SERVICE BULLETIN SB15-1

The purpose of this Service Bulletin is to inform operators that the D3190-1 Chafing Shields on D407-667-205 Crosstubes at CHG 006/007/008 may have been installed at the incorrect location as shown in Figure 1 below. This issue has been corrected for D407-667-205 at CHG 009 and subsequent.

Figure 1 - Incorrect D3190-1 Chafing Shield Placement

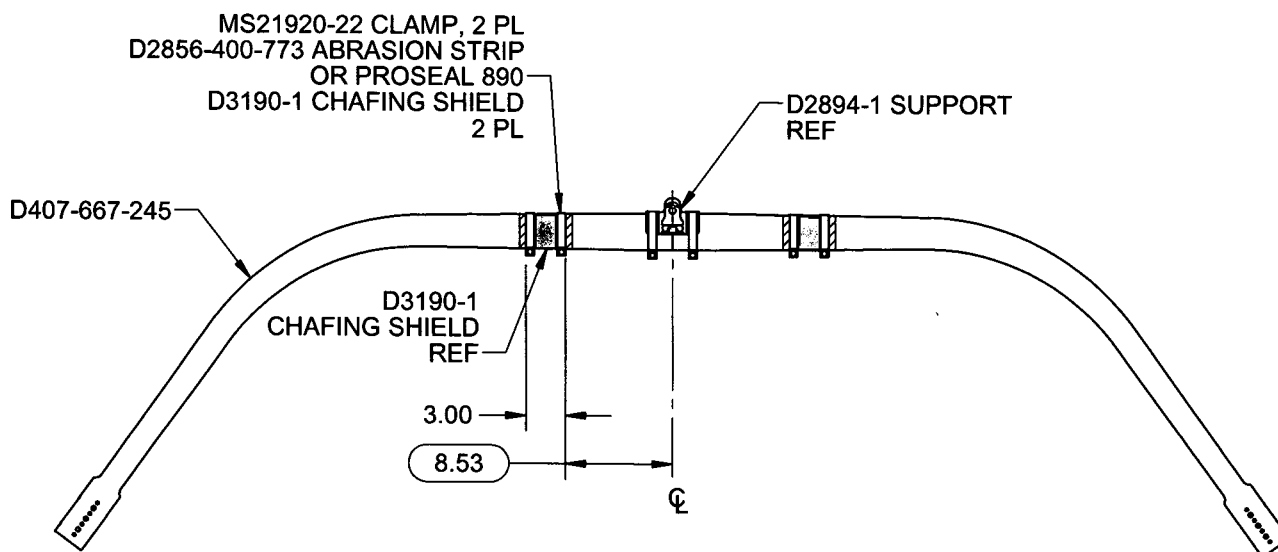
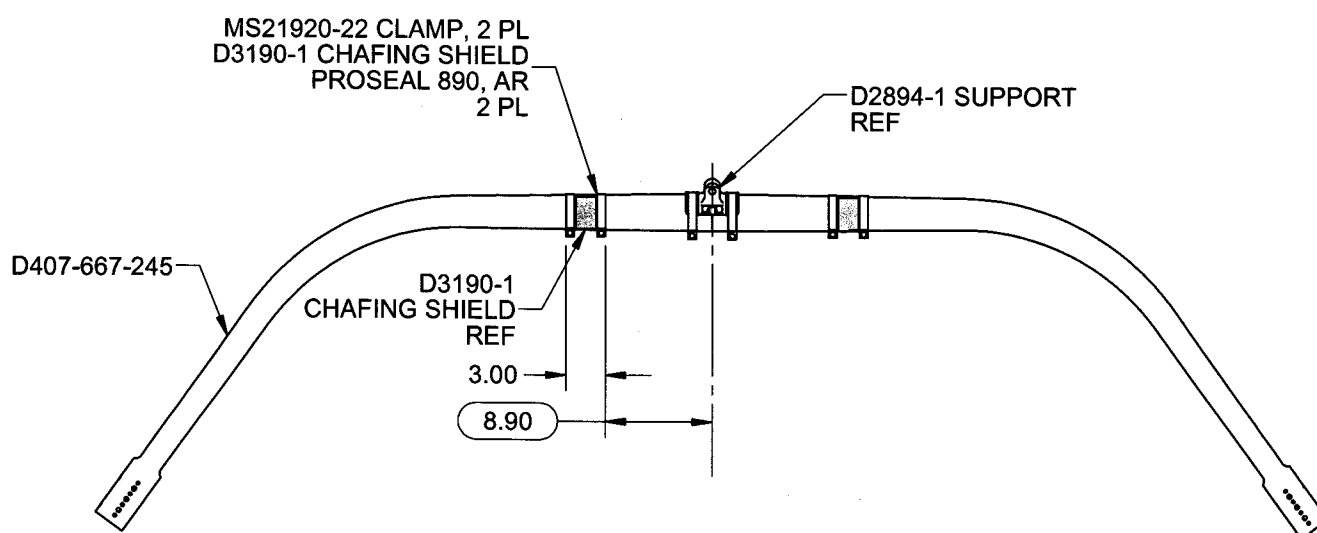
If the D3190-1 Chafing Shields have been installed per Figure 1, damage may occur on the strap assemblies (ref. P/N 400-052-015-101 or equivalent). Therefore, at the next scheduled 300 hour inspection or if damage is seen on the strap assemblies, the following procedure must be completed:

1. Remove the D407-667-205 Crosstube Installation from the aircraft per Paragraph 32.1 of ICA-D206-667.
2. Remove the D3190-1 Chafing Shield and D2856-400-773 Abrasion Strip (if present) per Paragraphs 32.7 and 32.5 respectively of ICA-D206-667.
3. Complete the 300 Hour Inspection and touch up finish as required.
4. Install the D3190-1 Chafing Shields in accordance with Paragraph 32.8 of ICA-D206-667 and Figure 2 of this Service Bulletin.
5. Re-install the D407-667-205 Crosstube onto the aircraft per Paragraph 32.2 of ICA-D206-667.

Figure 2 - Correct D3190-1 Chafing Shield Placement
